7 April 2026

Lara Farms Pty Ltd

Greater Geelong Planning Scheme Amendments C444 & C453 Transport Evidence Statement

Figure 2.10 Existing Traffic Volume Midblock Capacity Review

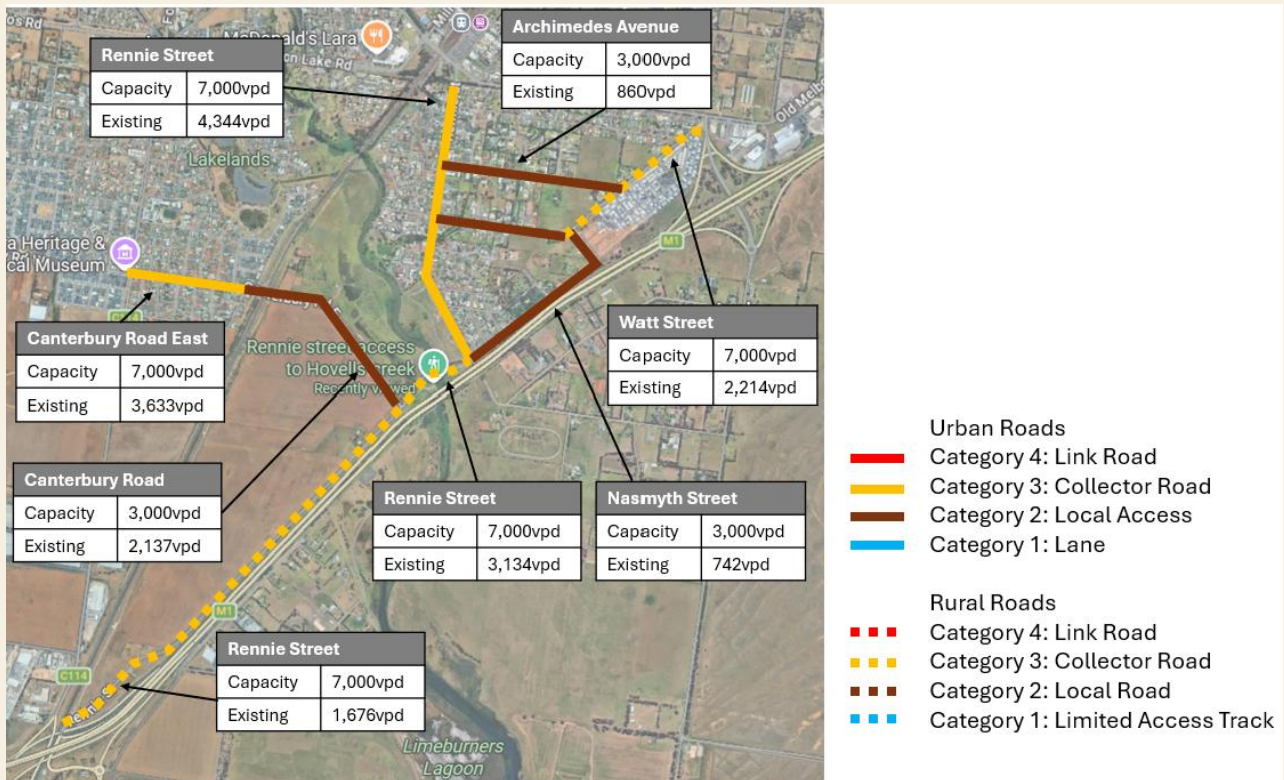
From this assessment, I observe the following:

- The assessed roads operate below their theoretical capacities, noting that there is significant latent capacity on each of the Collector Roads.
- The traffic volumes on Canterbury Road East between the railway line and Rennie Street are nearing their capacity, noting that this section of Canterbury Road is classified as a Local Access Road³, whereas the section to the west of the railway line is classified as a Collector Road with a higher theoretical capacity.

² I note that my assessment differs to the Traffix assessment as we have adopted different theoretical capacity volumes. Specifically, whilst Traffix has sourced these capacities from a superseded version of the City of Greater Geelong Municipal Road Management Plan (dated 25th May 2021), I observe that the more recent version of the Plan (2025) does not include daily traffic volume thresholds. I consider it appropriate to use Clause 56.06 capacities. The differences include:

- For Local roads, I have adopted a capacity of 3,000vpd (whereas Traffix adopt 2,000vpd)
- For Connector Roads, I have adopted a capacity of 7,000vpd (whereas Traffix adopt 5,000vpd)

Figure 5.2: Forecast Traffic Generation and Distribution

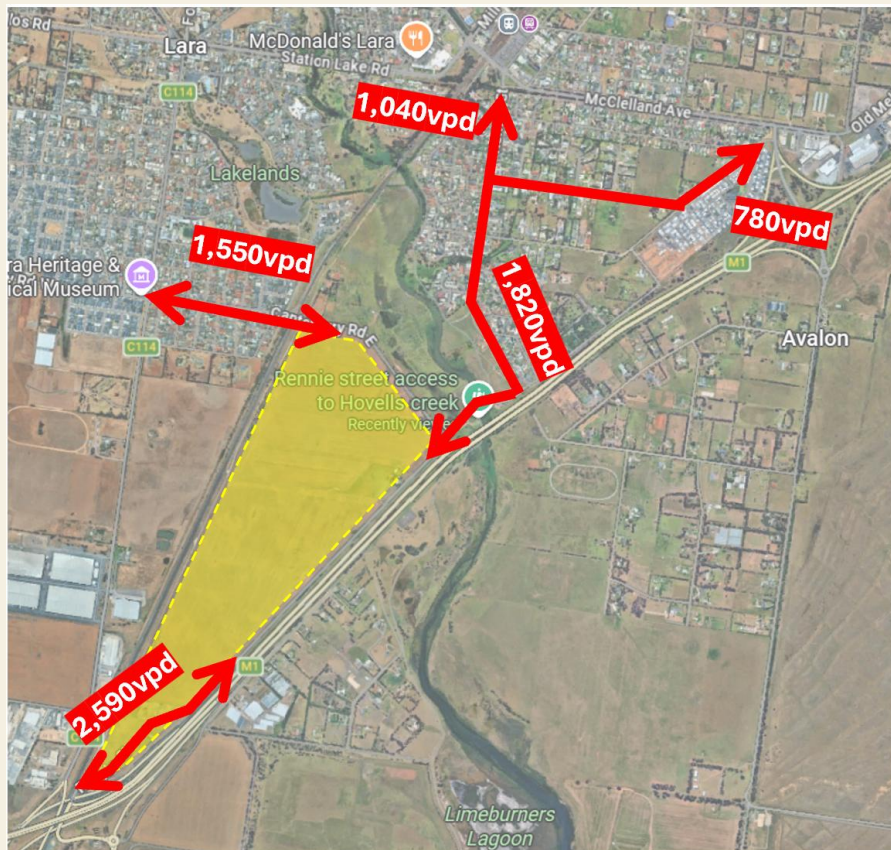
The adopted traffic distributions for the residential traffic, industrial traffic (light vehicles) and industrial traffic (heavy vehicles) are presented in Figure 45, 46 and 47 of the Traffix Report. Based on my research, I am satisfied that the adopted traffic distributions are acceptable for assessment purposes.

Based on the distributions outlined in the Traffix TIA report, the forecast additional daily traffic volumes on the surrounding road network (vehicle access routes identified above) are presented in **Figure 5.2**. I note that the below figures include the regional sports reserve (i.e. higher traffic generation estimate).

Figure 5.3: Daily Traffic Volume Capacity Assessment

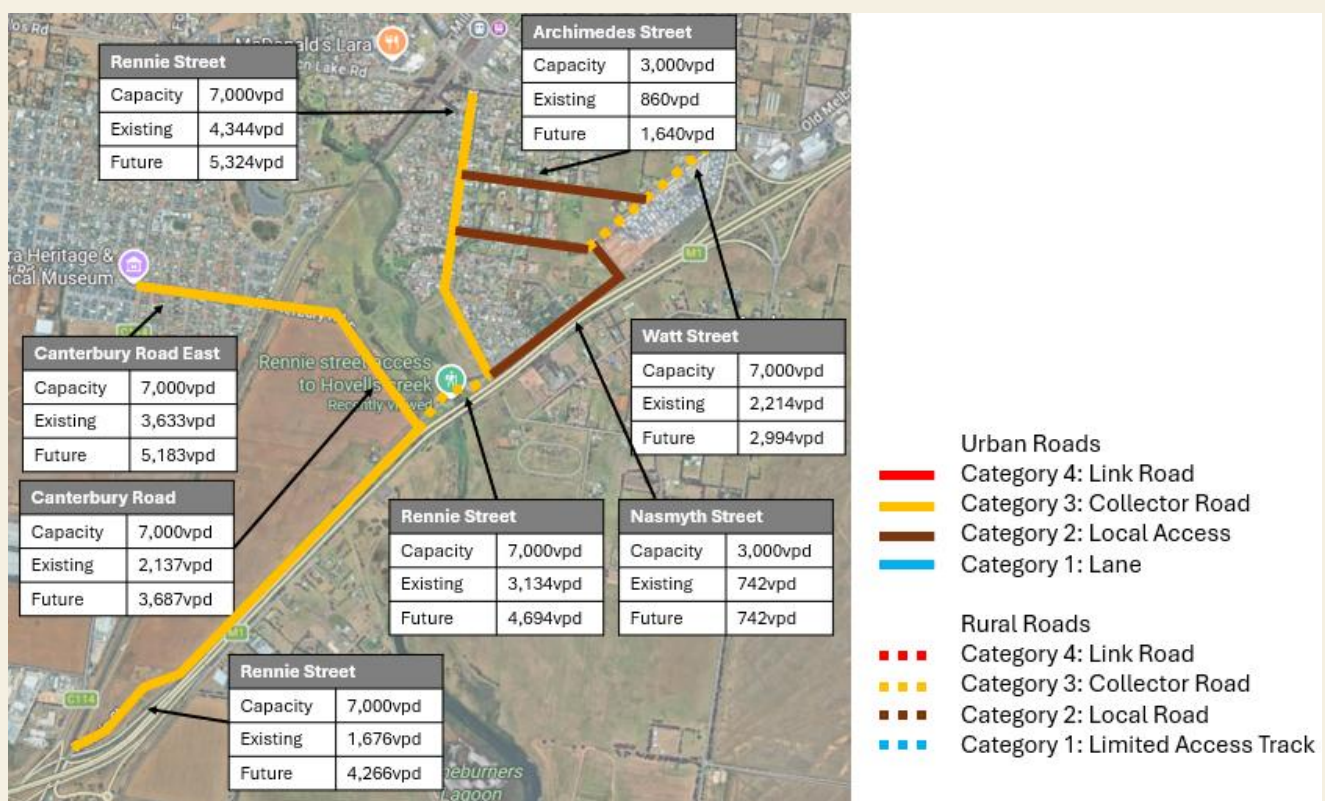
As outlined earlier in footnote 2, I note that the midblock capacities adopted in the Traffix assessment are based on capacities defined in the City of Greater Geelong Municipal Road Management Plan (dated 25th May 2021). However, I observe that the capacity thresholds have been removed from the most recent version of the document (Version 9.0, adopted 28th October 2025). In this context, I consider it appropriate to defer to the road capacities identified in Clause 56.06 of the Greater Geelong Planning Scheme.

A summary of the daily traffic volume capacities, existing daily traffic volumes and post development traffic volumes for key roads surrounding the subject site are presented in **Figure 5.3**.

Importantly, I note that this assessment assumes that Canterbury Road East (west of the railway line) and Rennie Street (south of Canterbury Road East) are classified as Collector Roads and have a daily traffic volume capacity of 7,000vpd. I consider this appropriate given the characteristics of these roads.

[1] As outlined above, this figure adopts the same capacities for roads to the existing version presented in Section 2.4 of this report with the only exception being that I have adopted a capacity of 7,000vpd for Canterbury Road East between the railway line and Rennie Street.
